Phase Out Notice for AIM-P508A0 Simple Charger Cradle

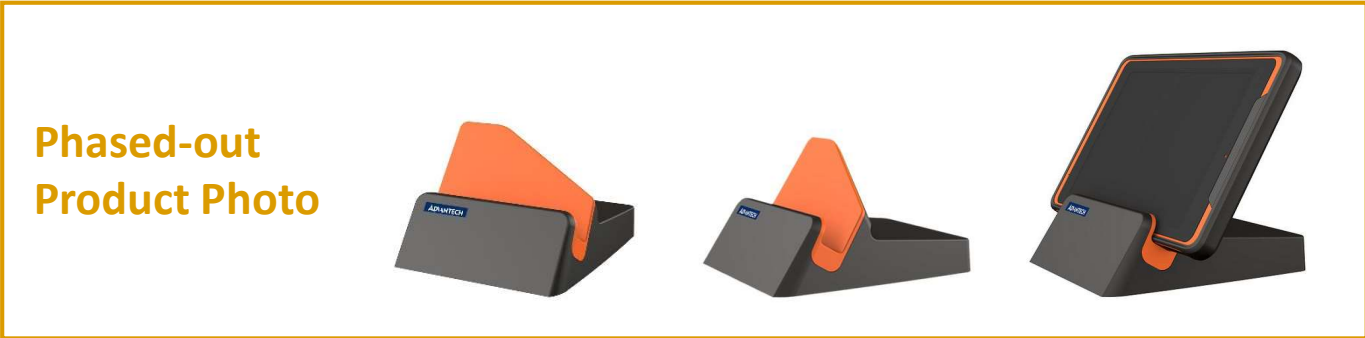
Advantech hereby announces the **end-of-life** for the **AIM-P508A0** simple cradle. This decision is primarily due to the inability of the AIM-P508A0's single USB 2.0 I/O to meet the economic scale of production.

To ensure continued support and increased functionality, the AIM-P508A0 will be **replaced** by the **AIM-P508B0**. The AIM-P508B0 features a more comprehensive I/O configuration, including two USB 3.0 ports, a COM port, and an RJ45 port, providing enhanced connectivity options.

Function	AIM-P508A0 (Phase Out)	AIM-P508B0
POGO Pin	5V/3A Charger	9V/2A Charger
I/O Port	1 x DC IN (micro USB type with 5V/3A input) 1 x USB 2.0 Type A	1 x DC IN (DC Jack with 12V/3A input) 2 x USB 3.0 Type A 1 x COM Port (RS232) 1 x RJ45
